**NETWORK RAIL
PROPOSED CHANGE IN SPEED LIMIT &
PEDESTRIAN ROUTE
A670 OLDHAM ROAD, UPPERMILL**

STAGE 1/2 - ROAD SAFETY AUDIT

FEBRUARY 2026

Drawing number
NRMOORGATE.2/01

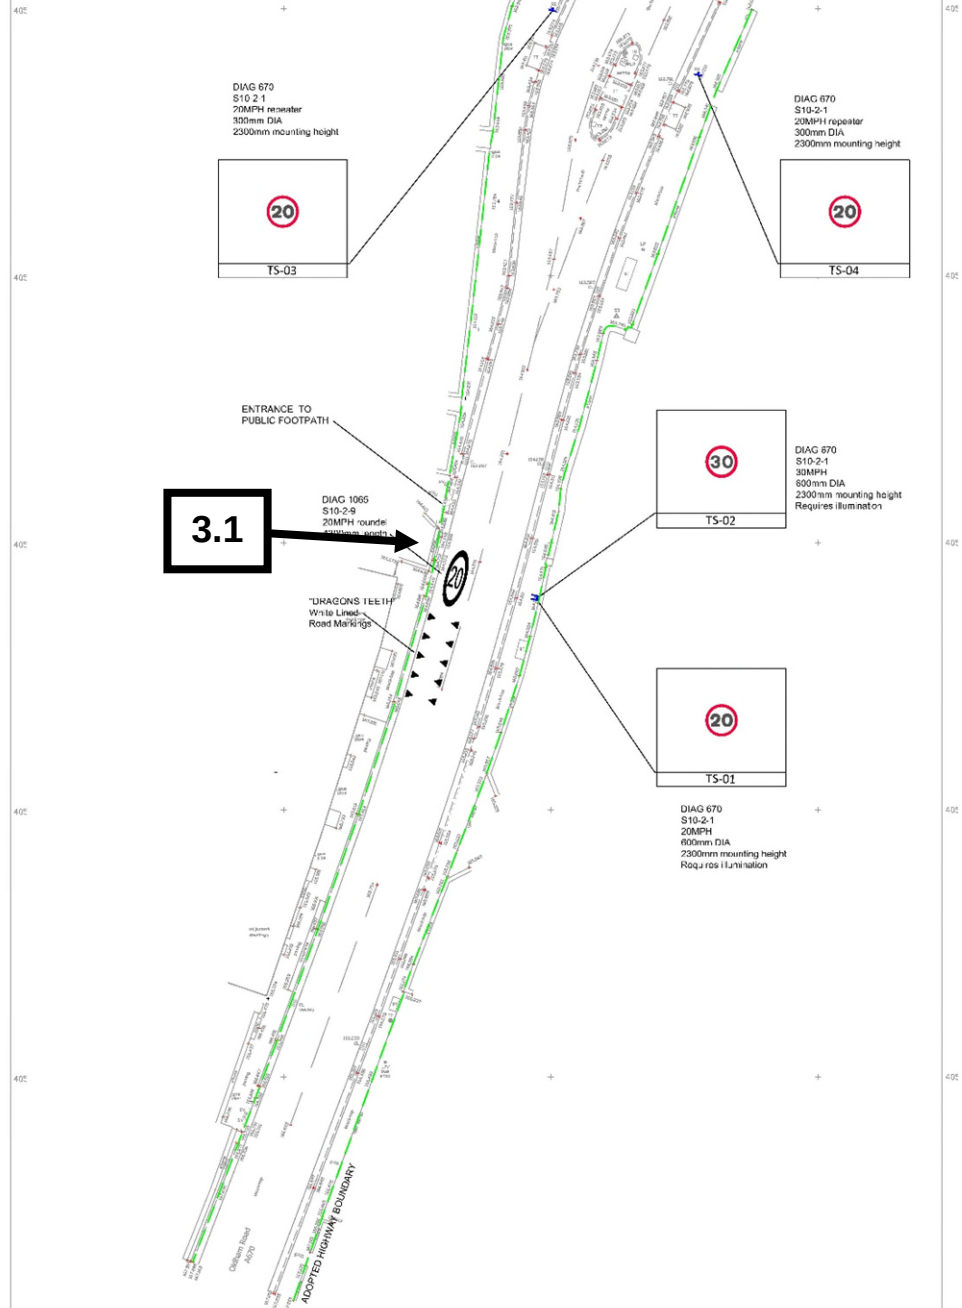
Location: A670 Oldham Road, west side (please refer to reference point 3.1 in Appendix B).

Summary: Insufficient footway width.

The west side of Oldham Road, between the Public Footpath (sited between No. 6 and No. 8) and the Huddersfield Narrow Canal, will form part of the proposed alternative pedestrian route, following the proposed extinguishment of a rail level crossing and Public Footpath No. 209SADD.

The Audit Team are concerned that a circa 10m length of existing footway on the west side of Oldham Road, immediately to the north of the Public Footpath identified, is very narrow and is considered insufficient in width. As a result, it is likely that either pedestrians could stray into the northbound lane of the carriageway, or southbound pedestrians will need to cross over to the south side utilising the existing uncontrolled crossing, proceed southbound, and then crossing back over to the west side opposite the Public Footpath, and vice-versa for northbound pedestrians.

The Audit Team acknowledge the land constraints at this location and accept that it might not be cost effective or practical to widen the narrow footway identified. Although this would be the preferred option if practical.

It should also be noted that this alternative pedestrian route would not be accessible or recommended to mobility or vision impaired pedestrians due to the uneven ground and steps that form part of the route to the west of Oldham Road. On this basis, the following recommendation is based on only able-bodied pedestrians being able to utilise this section of the proposed alternative route.

It is recommended that:

- a. If practical and cost proportionate, provide a minimum 1.2m width footway on the north side of Oldham Road, to the east of the Public Footpath identified. If this is not practical, then:

- b. Provide advanced warning sign (Diag 544.1) to the south of the Public Footpath, facing northbound traffic, to warn road users to anticipate pedestrians in the carriageway.
